Access Compliance Report

Public Rights-of-Way

(Curb Ramps)

Intersection ID: N/A	Main Street: SPEER_BV	Cross Street: NATIONAL_AV	Location: NE
ADA ID: E301A22AD642	Ramp Type: BlendTrans1	Initial Pass/Fail: Pass	Overall Compliance: No
Severity Score: 5			
Codes/Mitigation Info/Possible Solution		Field Measurements/Component Compliance

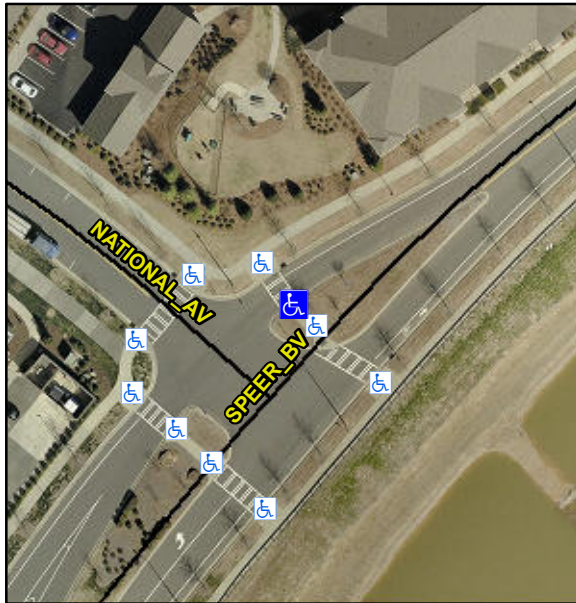
LOCATED ON MEDIAN

R304.5.4

Remove & Replace Gutter.
